SUBJECT LAND: 121 Burnley Street, Richmond

Subject: Application No: PLN19/0918

Description: Office and Warehouse Development Site Address: 121 Burnley Street, Richmond

City of Yarra Heritage Advice

Above: Corrected sightline over main ridgeline shows extent of proposed additions that will be visible from the street in yellow.

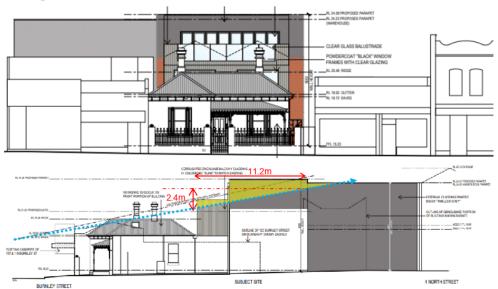
The proposed front setback for the new development from Burnley Street will be behind the full roof form of the heritage building. On this basis, the front setback of the proposed addition is supported but the height of the addition is not.

The proposed finished height for the new addition will be over 9.35 metres. The facade heights of the adjacent properties are between 3.5 and 4 metres lower.

The submitted sightline assessment is incorrect as it does not touch the main roofline. The corrected sightline assessment shows that the proposed front open deck on level 2 will be visible from both directly in front of the site, as well as from oblique angles. All activity and items located on the deck will also be clearly visible. Not only this, almost all of the second-floor level will also be visible due to the glazed balustrading of the proposed front open deck. The visibility and proximity of the proposed second floor level and open deck will dominate the original heritage building and is therefore not acceptable as currently proposed.

The proposed open deck on the second-floor level must be deleted or relocated down to the first-floor level, preferably utilising the existing double pitched parapet of the upper floor façade as its balustrade.

Some visibility of the proposed second floor level is considered acceptable, however the extent currently proposed is excessive as it will dominate the appearance of the original heritage building from Burnley Street. For this additional floor level to remain, it would need to be setback at least 11.2m from the rear of the heritage building so that it might be perceived as a separate building at the rear. This setback could be reduced if the overall finished height of the addition is lowered.

Suggested condition	Explanation
1.	That the proposed front open deck behind the heritage house must be relocated to level 1 or deleted.	The proposed open deck will be visible from the street rising above the roof of the heritage building and

2.	That the proposed second floor addition must be setback at least 11.2m from the rear of the heritage house	The setback of the second floor is recommended to reduce that dominance of the addition on the appearance of the original heritage building from Burnley Street, and create the perception that the addition is part of a separate building at the rear.
3.	That the façade of the proposed second floor addition must be finished in a natural cement colour	The colour of the proposed second floor addition should be in keeping with the existing rear addition to minimise its dominance.
